PD Modification Application: PRS 22-0618

BOCC Land Use Meeting Date: May 10, 2022

Hillsborough County Florida

Development Services Department

2.5 Proposed Site Plan (partial provided below for size and orientation purposes. See Section 8.2 for full site plan)

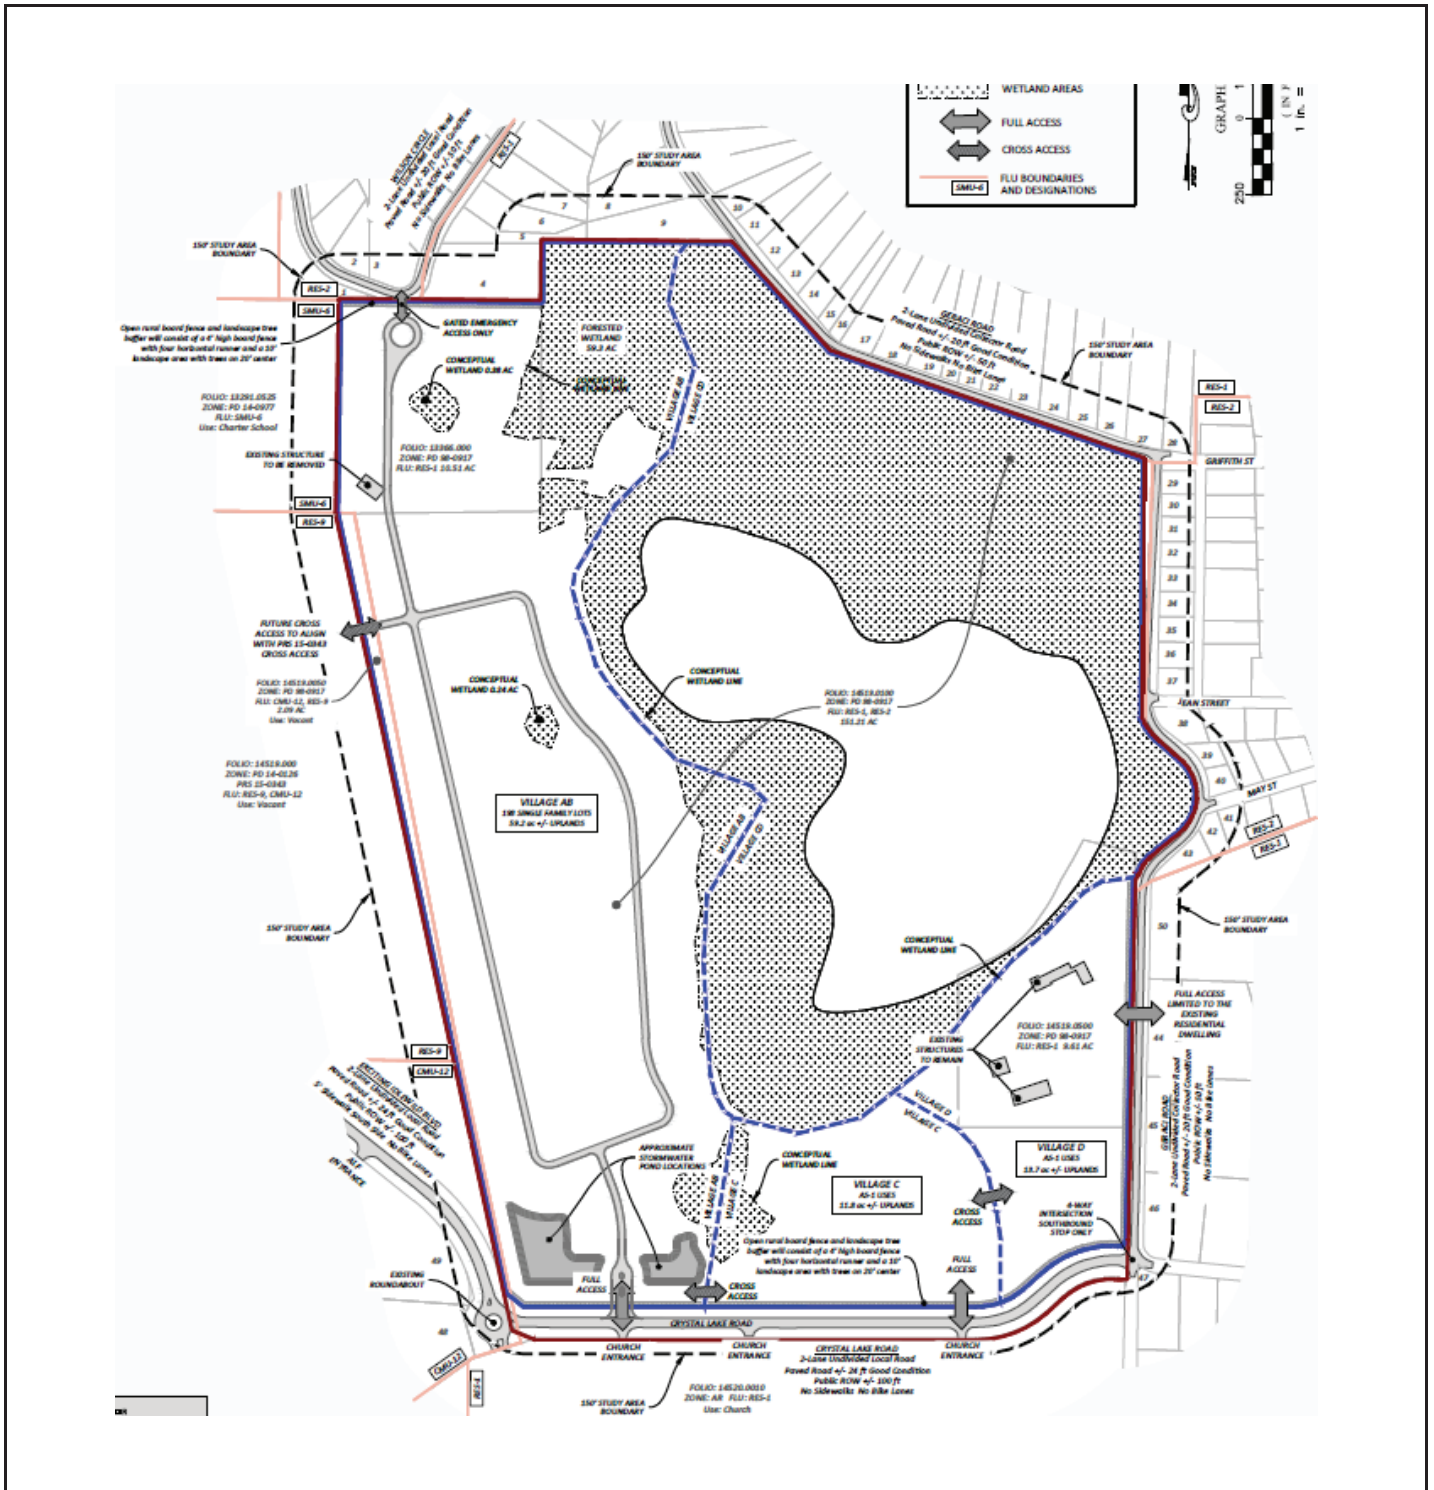
Notes: Applicant proposes emergency access only to the north. The proposed change is not consistent with LDC, Sec. 5.01.01. D. Compliance with Comprehensive Plan, Sec. 5.03.01.a. Intent of Planned Developments, Sec. 5.03 Planned Development Access and Connectivity Standards and Sec. 6.02.01. Subdivision Access to Public Roads.

Figure 1: Approved Access and Cross Points for PD 98-0917

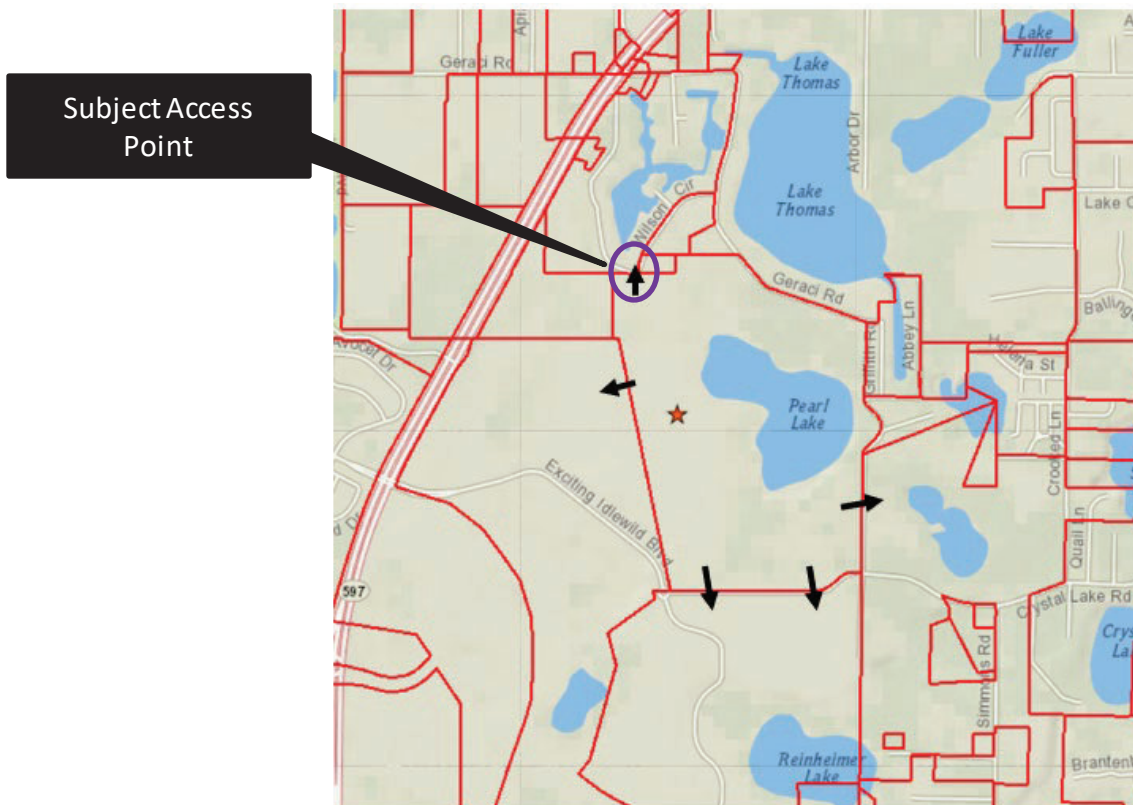
Per the applicant's request, the removal of this access is proposed due to the adjacent property being a low density residential development and therefore not compatible with the subject property when the connection is provided. Furthermore, the applicant's request states the access is not needed and not supported by residents.

Transportation staff has reviewed the request and objects due noncompliance with Land Development Code requirements, noncompliance with the Comprehensive Plan and the additional travel time and distance without the connection to reach area commercial uses, office uses and schools.

Route from Wilson Cir. Access Connection: +/-3,000ft (0.57 miles) Total, +/-630ft along Dale Mabry Hwy, +/-2,370ft along Wilson Rd., a local roadway.

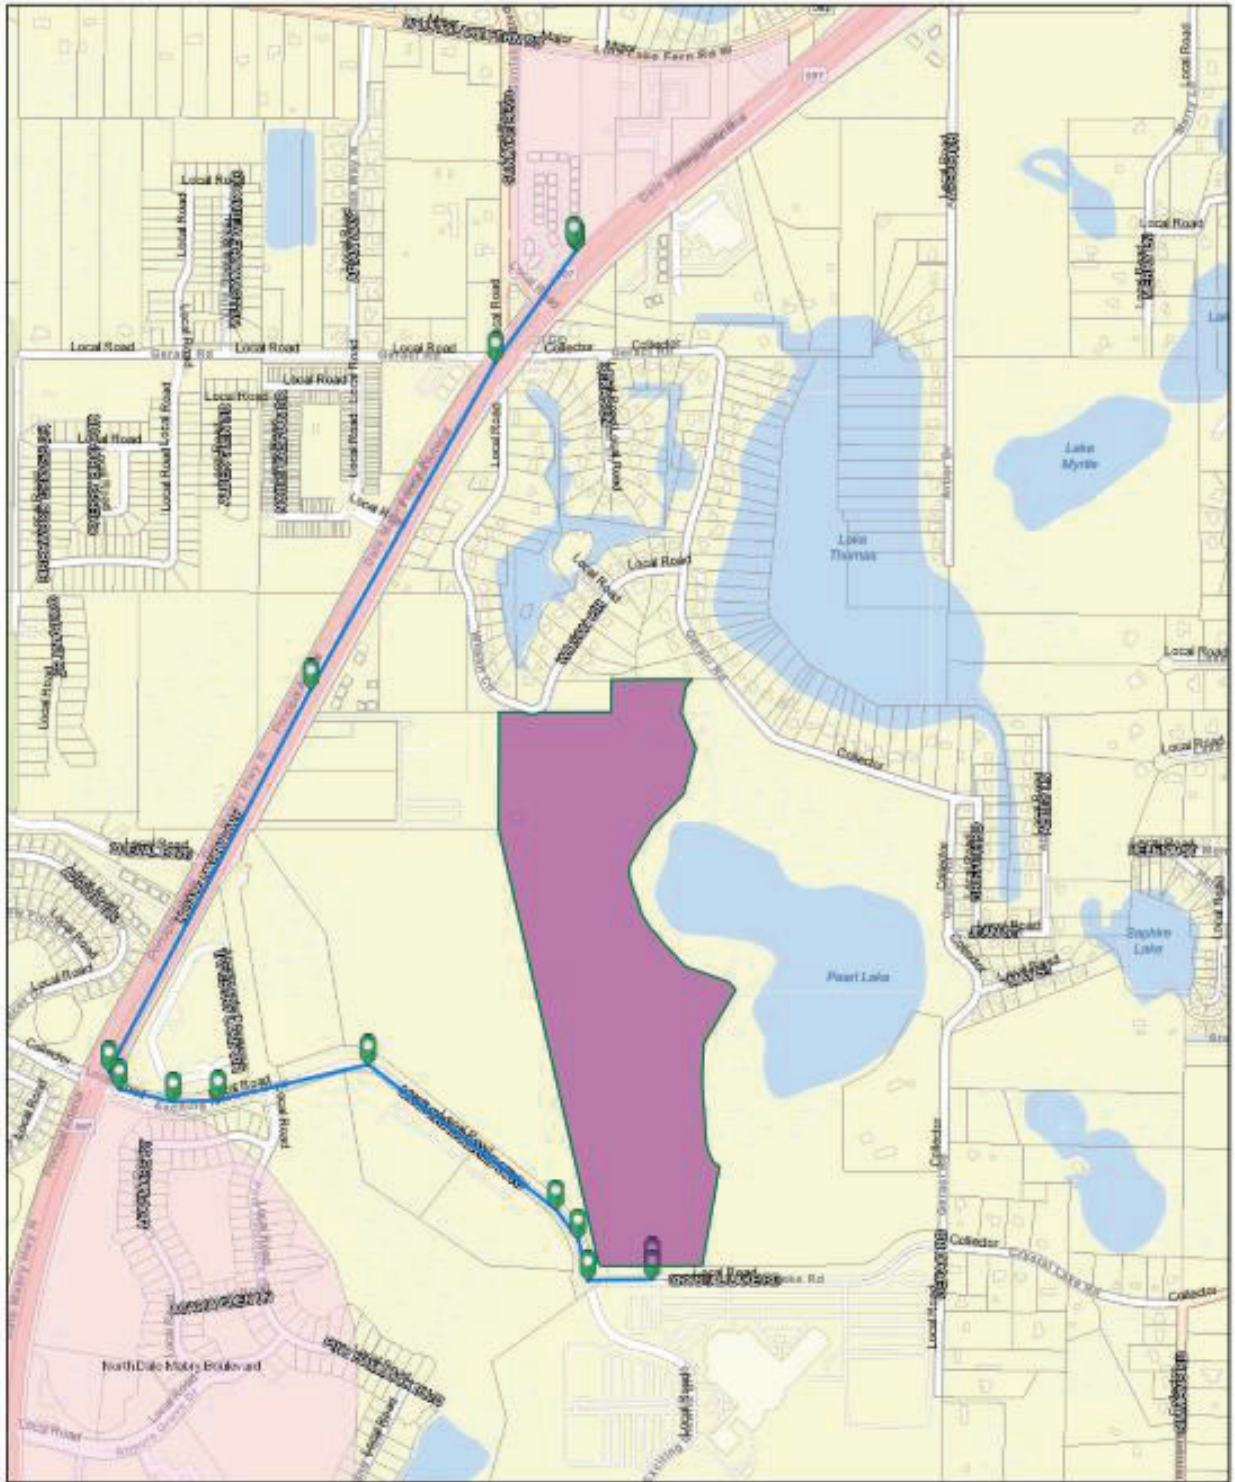
As shown below, staff conducted an analysis of available routes to access the North Dale Mabry Activity Centers and calculated the distances from the Wilson Rd. access connection (proposed to be eliminated) and the Crystal Lake Rd. access connection (the closest planned access connection to remain) to Activity Centers to the north of the subject planned development. The below table summarizes the distances calculated and provides the percentage of the route which is along a collector or arterial roadway.

Elimination of the vehicular and pedestrian connectivity to Wilson Rd. will make vehicular and pedestrian trips to the activity center in the Special Public Interest-North Dale Mabry Overlay (SPI-NDM) zoning district (commercial corridor) for future residents of the subject planned development longer and less convenient; and unnecessarily place more vehicle trips on arterial and collector roadway.

Route from Wilson Cir. Access Connection: +/- 4,400 feet Total, +/- 2,245 feet Along Dale Mabry Hwy.

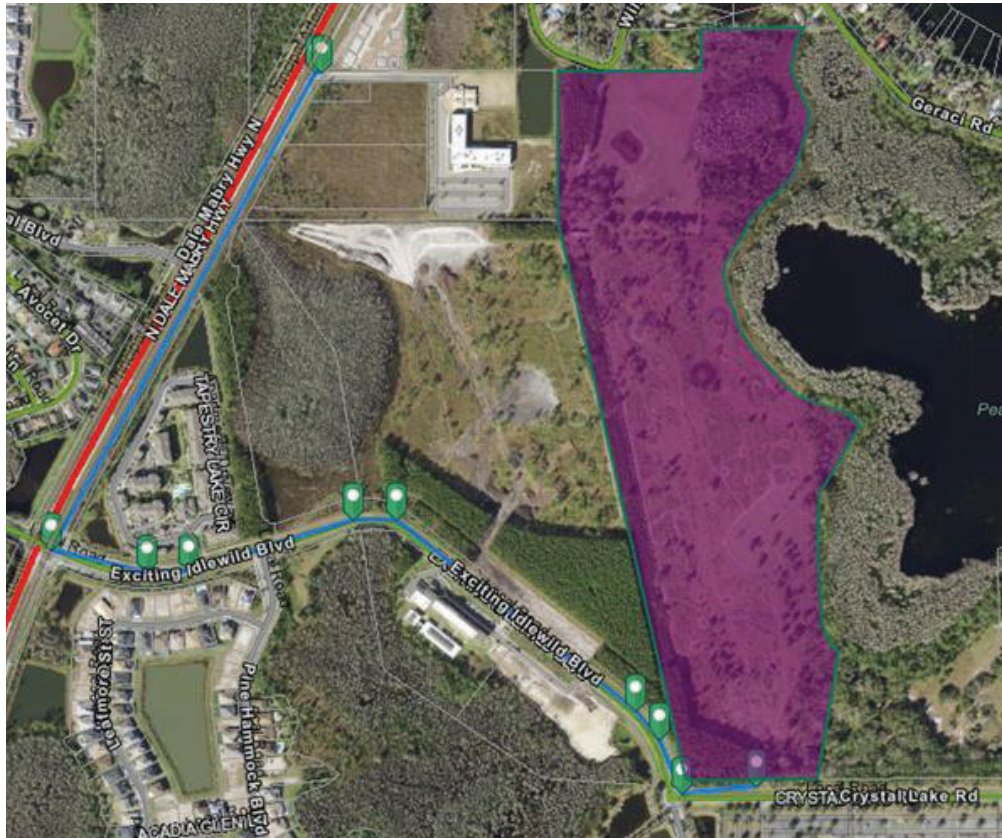
As shown below, staff conducted an analysis of available walking routes and calculated the walking distances from the Wilson Rd. access connection (proposed to be eliminated) and the Crystal Lake Rd. access connection (the closest planned access connection to remain) to Sunlake Academy charter school site on Dale Mabry Highway. The below table summarizes the walking distances calculated and provides the percentage of the walking route which is along a local, collector or arterial roadway.

Given the above, the shortest route for schoolchildren that may walk to the Sunlake Academy charter school is from the Wilson Rd. access connection.

Route from Wilson Cir. Access Connection: +/-3,000ft (0.57 miles) Total, +/-630ft along Dale Mabry Hwy, +/-2,370ft along Wilson Rd., a local roadway.

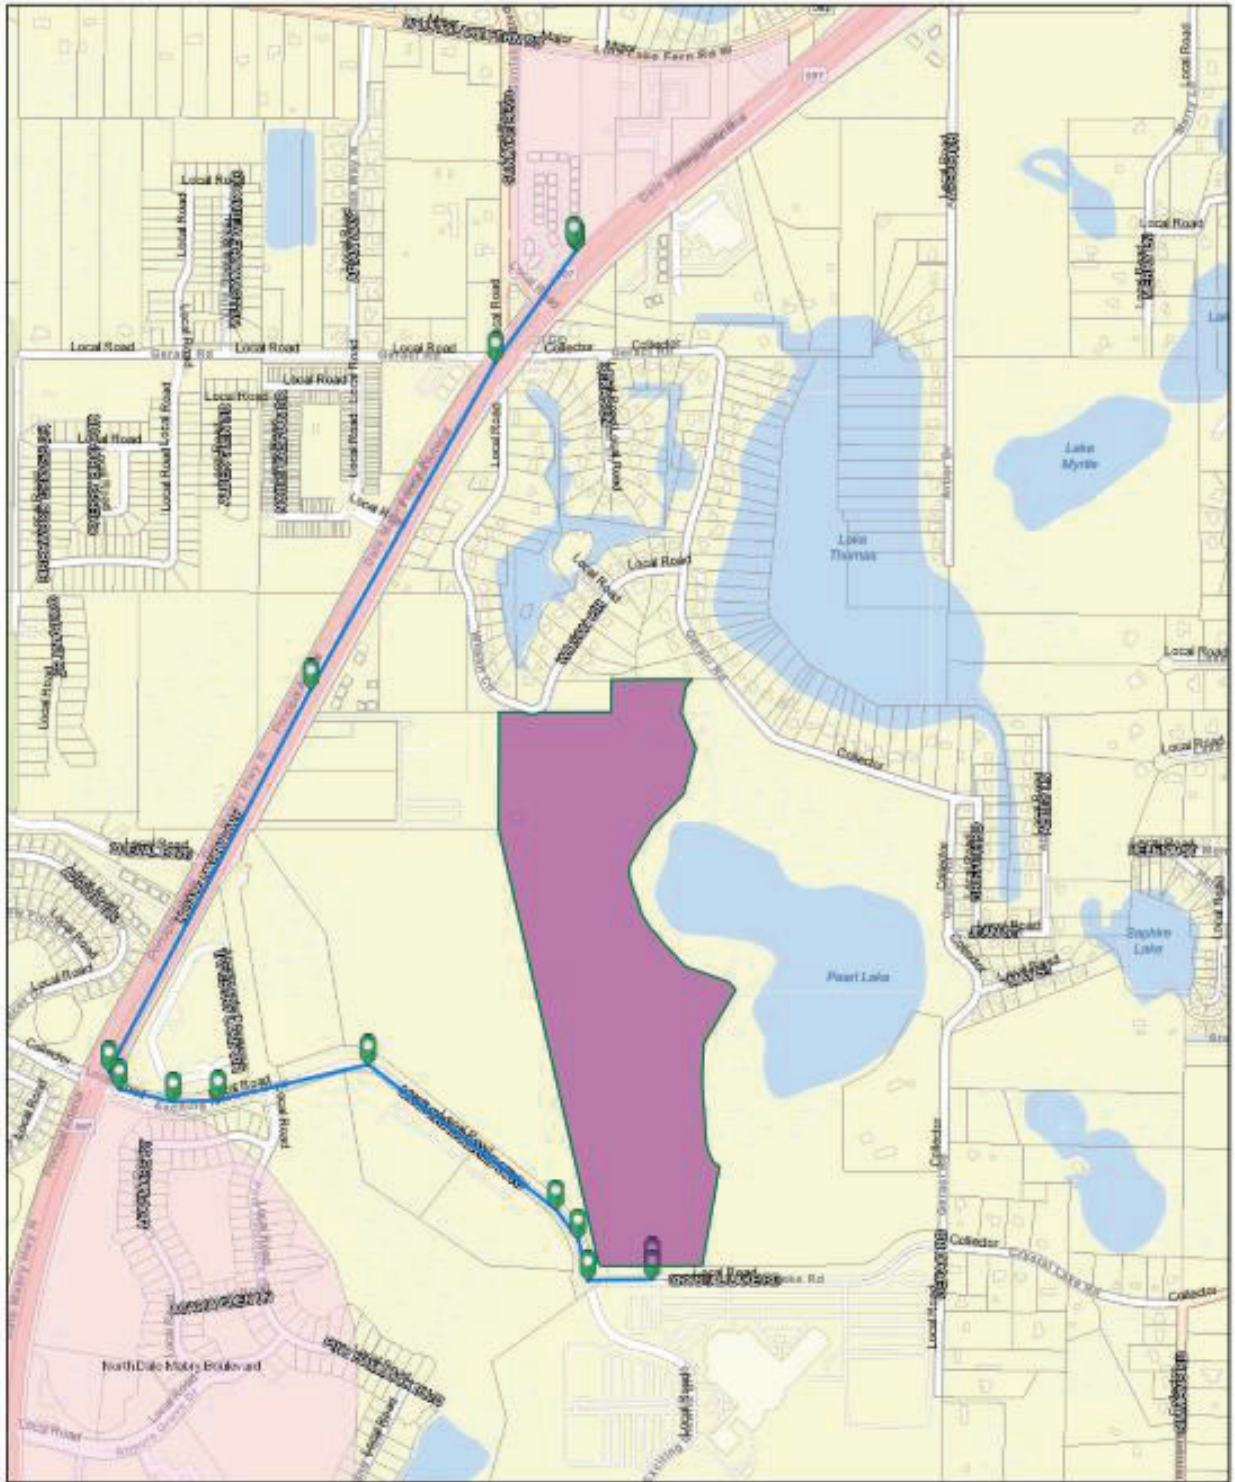
As shown below, staff conducted an analysis of available routes to access the North Dale Mabry Activity Centers and calculated the distances from the Wilson Rd. access connection (proposed to be eliminated) and the Crystal Lake Rd. access connection (the closest planned access connection to remain) to Activity Centers to the north of the subject planned development. The below table summarizes the distances calculated and provides the percentage of the route which is along a collector or arterial roadway.

Elimination of the vehicular and pedestrian connectivity to Wilson Rd. will make vehicular and pedestrian trips to the activity center in the Special Public Interest-North Dale Mabry Overlay (SPI-NDM) zoning district (commercial corridor) for future residents of the subject planned development longer and less convenient; and unnecessarily place more vehicle trips on arterial and collector roadway.

Route from Wilson Cir. Access Connection: +/- 4,400 feet Total, +/- 2,245 feet Along Dale Mabry Hwy.

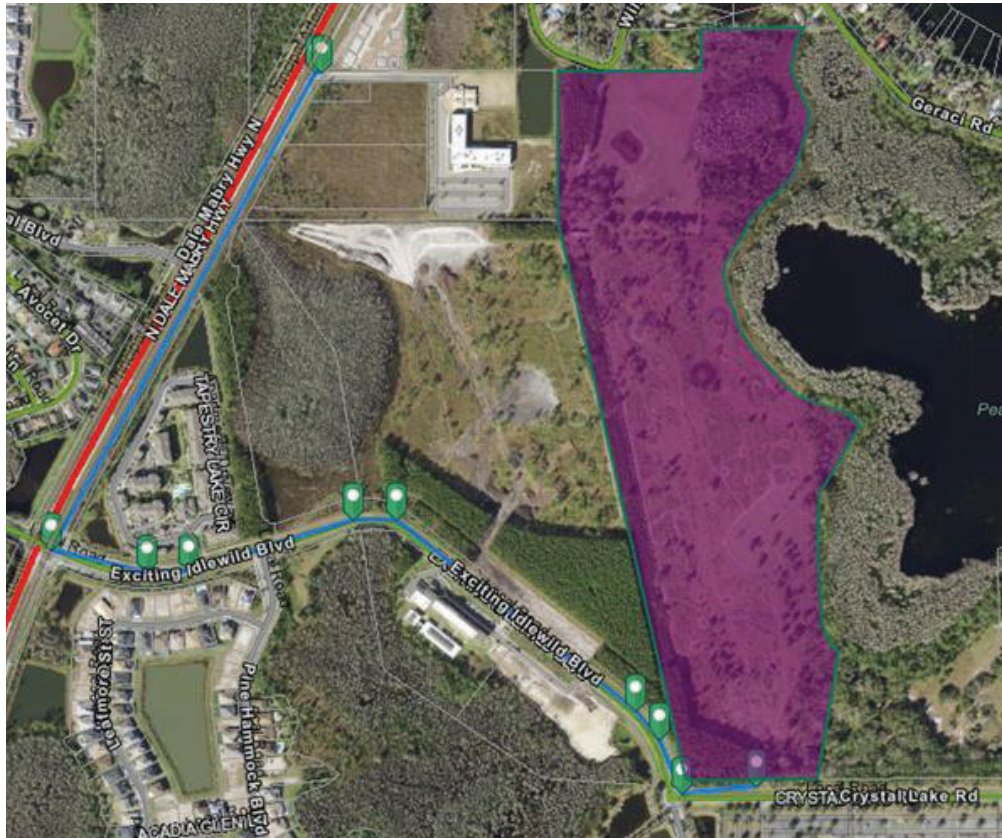
As shown below, staff conducted an analysis of available walking routes and calculated the walking distances from the Wilson Rd. access connection (proposed to be eliminated) and the Crystal Lake Rd. access connection (the closest planned access connection to remain) to Sunlake Academy charter school site on Dale Mabry Highway. The below table summarizes the walking distances calculated and provides the percentage of the walking route which is along a local, collector or arterial roadway.

Given the above, the shortest route for schoolchildren that may walk to the Sunlake Academy charter school is from the Wilson Rd. access connection.
